BCA COMPLIANCE ASSESSMENT PROPOSED BUILDING WORK

Change of Use & Alterations to Educational Establishment (Alesco Senior College)

27 Chapman Street CHARLESTOWN NSW

(Figure 1 – Exposure to a fire-source feature requiring Fire Resisting Construction)

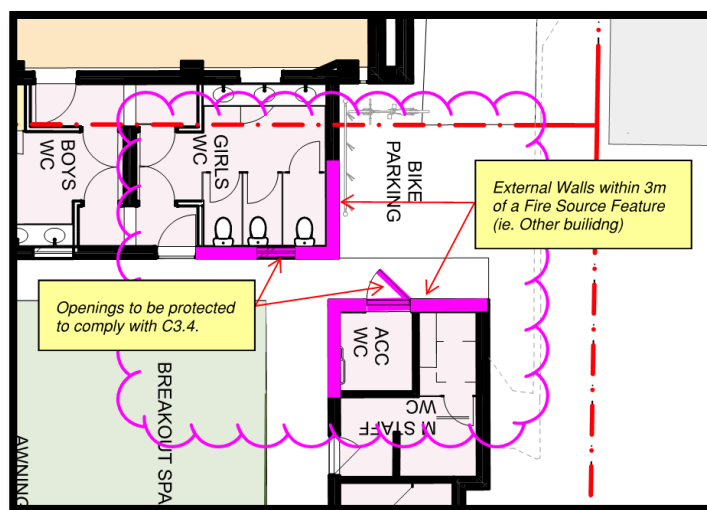
The External Walls of the buildings within 3m of a Fire-Source Feature are highlighted in the diagram above, the requirement to have fire-resisting construction is to reduce the fire compartment size to less than 500m².

The External Walls are constructed of masonry and may achieve the required FRL – this is to be confirmed by a Structural Engineer or evidence of a tested system.

The covered walkway structures (*Class 10a*) connecting the buildings are not considered to significantly contribute to the spread of fire and smoke between separate buildings – and are not Fire Source Features.

Any openings within the walls highlighted in *Figure 1* must comply with C3.4 - including:

(Figure 2 – Exit Doors swinging against the path of egress from the Multi-Purpose Centre)

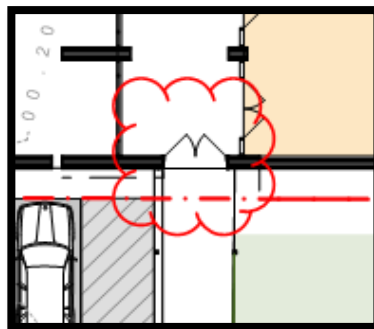
Exit Door from the Multi-Purpose Centre must swing in the direction of exiting the building. (D2.20(b))
